Q-335

SVE BULLETIN

2022MY F-650/750 GAS ENGINE COOLING IMPROVEMENTS

PREVIOUS MODEL YEAR SIDE-GRILLES

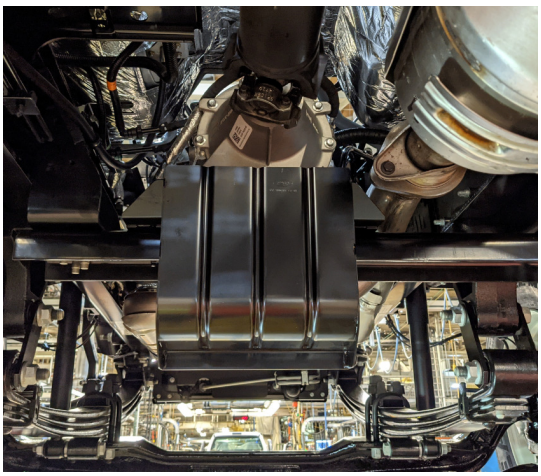
Side-Grille Openings: Provides improved and increased air cooling into the engine compartment. All F-650 / 750 vehicles will have this new improved side-grille opening.

NO SIDE-GRILLE OPENINGS

IMPROVED SIDE-GRILL OPENINGS

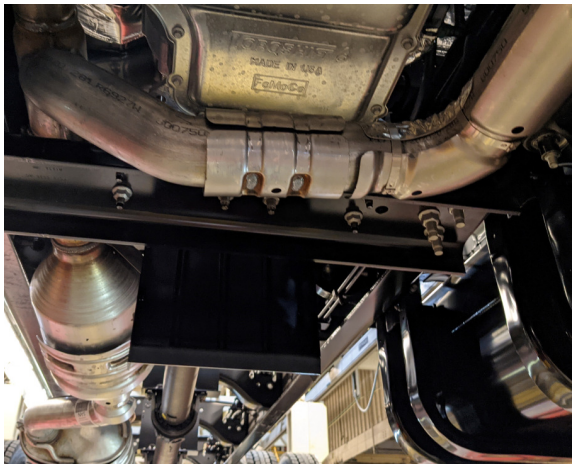
Driveshaft Air Deflector: A new air deflector is provided to cool the first driveshaft U joint. Do not modify or remove this sir deflector as premature failure of the U joint may occur. All Gasoline engine F650/750 vehicles have this deflector
